The Commission has issued the enclosed Amendment No. 113 to Facility Operating License No. DPR-59 for the James A. FitzPatrick Nuclear Power Plant. The amendment consists of changes to the Technical Specifications in response to your application transmitted by letter dated March 16, 1987.

AMENDMENT TO FACILITY OPERATING LICENSE

Amendment No. 113
License No. DPR-59

SAFETY EVALUATION BY THE OFFICE OF NUCLEAR REACTOR REGULATION
RELATED TO AMENDMENT NO. 113 TO FACILITY OPERATING LICENSE NO. DPR-59

**FIGURE 3.6-1
 REACTOR VESSEL PRESSURE - TEMPERATURE LIMITS**

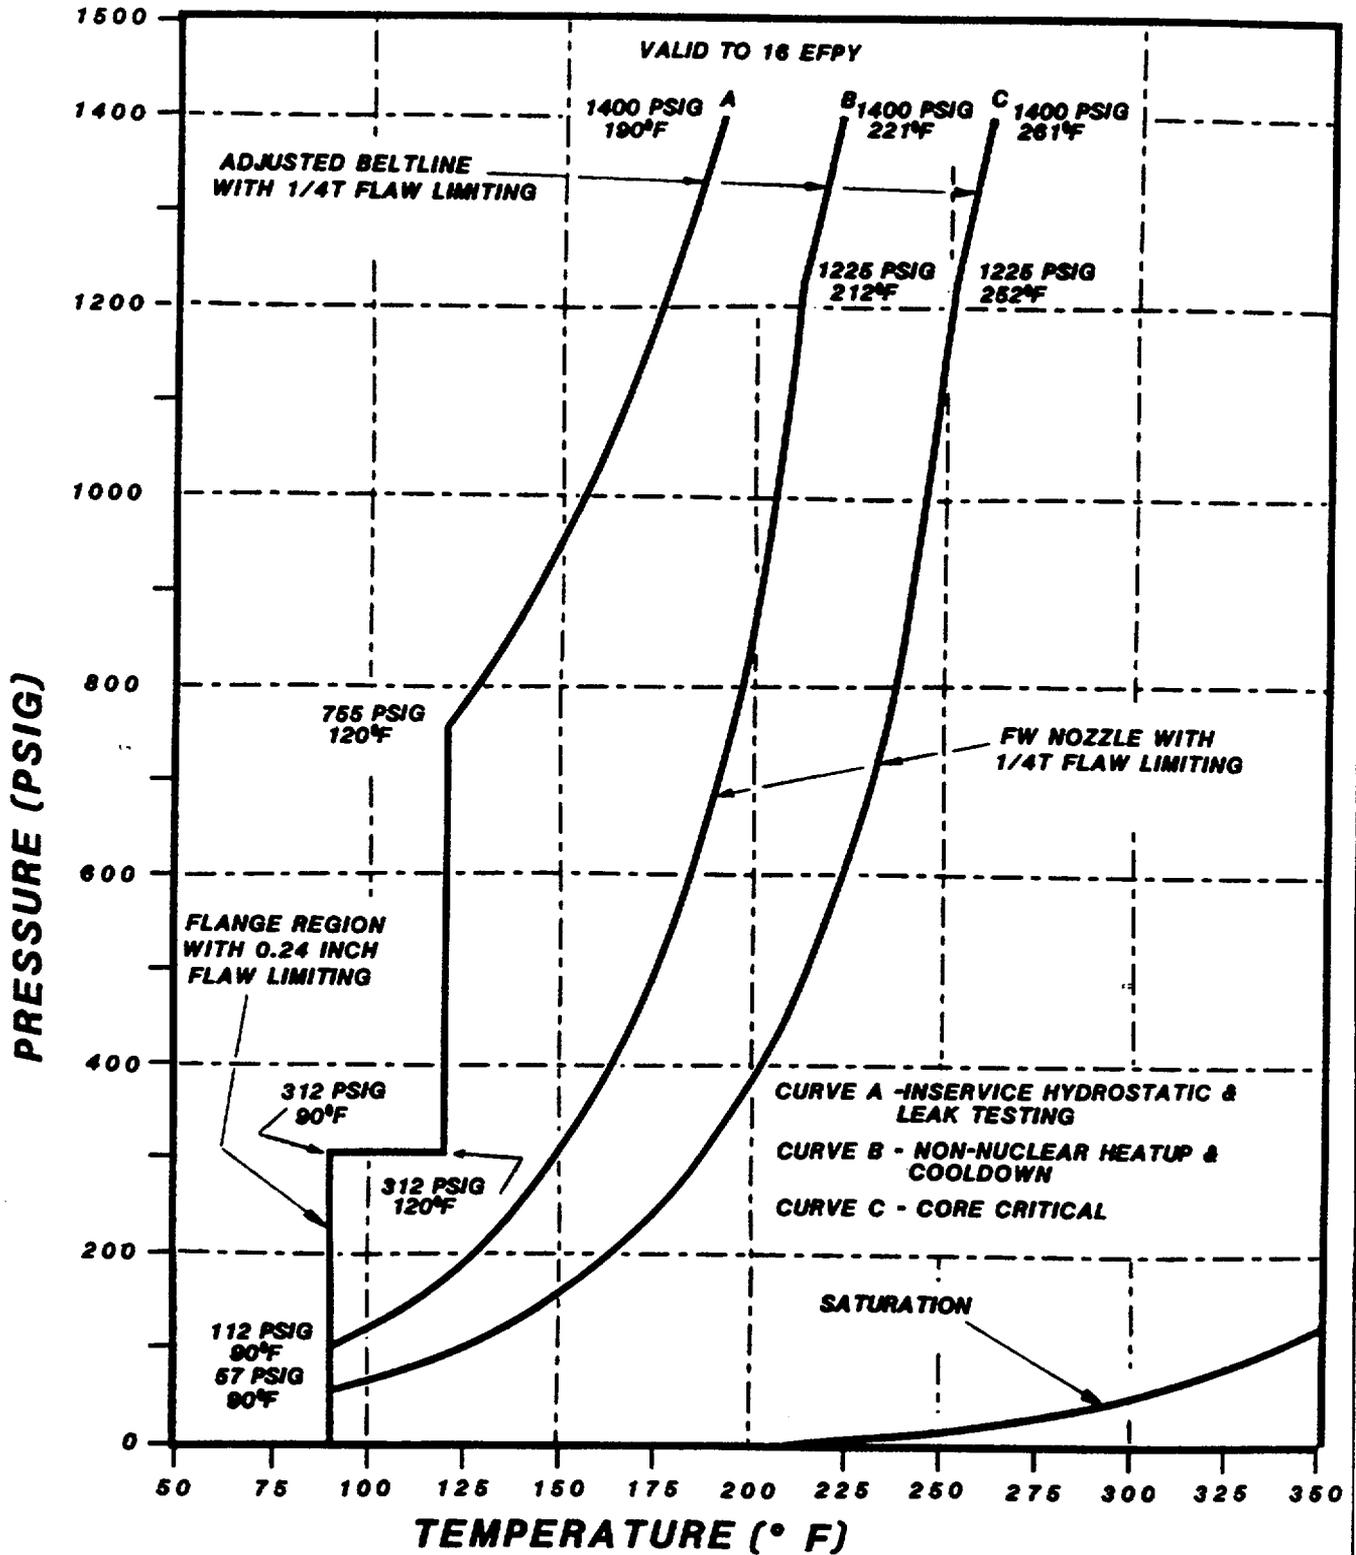
The amendment would change the Technical Specifications to include revised limits that restrict operating pressures and temperatures to assure that brittle fracture of the reactor vessel cannot occur and that vessel integrity is maintained.

The first surveillance capsule containing test specimens was withdrawn in April, 1985 after 6 EFPY. The test specimens removed were tested according to ASTM E 185-82 and the results are in GE report MDE-49-0386. The curves of Figure 3.6-1, A through C, reflect findings in the report related to copper-phosphorus content of the reactor vessel shell beltline, flux wire testing fluence distribution analysis, and Charpy V-Notch specimen testing. The next surveillance capsule will be removed after 15 EFPYs of operation and the results of the examination used as a basis for revision of Figure 3.6-1 curves A, B and C for operation of the plant after 16 EFPYs.

At higher temperature and pressure ranges, the pressure-temperature limits are based on the material that has the largest shift between the adjusted RT_{NDT} and the initial RT_{NDT} . The plate was found to be the limiting material for operation up to 16 EFPY and has an adjusted RT_{NDT} of 86°F. Beyond 16 EFPY, the weld will be the limiting material due to the higher irradiation shift. The staff has determined that the three proposed pressure-temperature curves satisfy the safety margins as required by Appendix G of 10 CFR 50.

In summary, the staff has determined that the licensee has adequate surveillance capsules for the reactor beltline materials inside of the reactor vessel and has an acceptable fracture toughness testing program for the irradiated materials. The licensee has appropriately applied Appendix G of 10 CFR 50 and Regulatory Guide 1.99, Revision 1, to develop the pressure-temperature limits. These limits are valid up to 16 EFPY and may be incorporated into the FitzPatrick TS.

During in-service hydrostatic or leak testing the Reactor Coolant System pressure and temperature shall be on or to the right of curve A shown in Figure 3.6-1 and the maximum temperature change during any one hour period shall be:

During heatup by non-nuclear means (mechanical), cooldown following nuclear shutdown and low power physics tests the Reactor Coolant System pressure and temperature shall be on or to the right of the curve B shown in Figure 3.6-1 and the maximum temperature change during any one hour shall be $\leq 100^{\circ}\text{F}$.

During all modes of operation with a critical core (except for low power physics tests) the reactor Coolant System pressure and temperature shall be at or to the right of the curve C shown in Figure 3.6-1 and the maximum temperature change during any one hour shall be $\leq 100^{\circ}\text{F}$.

Figure 3.6-1 curve A establishes the minimum temperature for hydrostatic and leak testing required by the ASME Boiler and Pressure Vessel Code, Section XI. Test pressures for in-service hydrostatic and leak testing are a function of the testing temperature and the component material. Accordingly, the maximum hydrostatic test pressure will be 1.1 times the operating pressure or about 1105 psig.

Figure 3.6-1, curve B, provides limitations for plant heatup and cooldown when the reactor is not critical or during low power physics tests. The thermal limitation is based on maximum heatup and cooldown rates of 100°F/hr in any one-hour period.

Figure 3.6-1, curve C, establishes operating limits when core is critical. These limits include a margin of 40°F as required by 10 CFR 50 Appendix G.
